Stage 04: Code Administrator Consultation

Grid Code

GC0101: EU Connection Codes GB Implementation – Mod 2

This proposal seeks to modify the Grid Code to comply with the obligations in the EU Connection Codes:

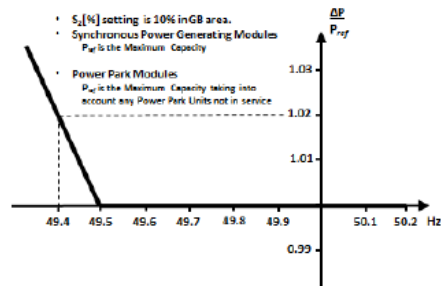
The figure X2 has a small note stating that the response for a power park module is based upon the number of power park units in service.

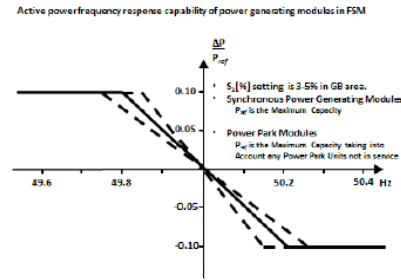
<p>The figure X3 has a small note stating that the response for a power park module is based upon the number of power park units in service.</p> <p>Windfarm manufacturers believed the windfarm operators and OEM's had the freedom to choose central or power park unit based frequency response (ECC6.3.7.3.1)</p> <p>With the advantage that a module approach would give the response based upon the available active power in the wind regardless of the unit available and not the number of WTG's in service.</p> <p>The unit approach enables the windfarm to decrease the power output when units are out of service.</p> <p>Now however it appears in the figures that there is no distinguishing between either approach. If it were treated as a module with a central controller the windfarm must de-rate the remaining available power to represent the loss of a unit in service.</p> <p>Finally The module approach has significant available capacity advantages over most of the operating range. Which would (with the Unit approach) have to be supplied by conventional or legacy generation, at extra cost. Surely there is a cost benefit advantage from the module</p>
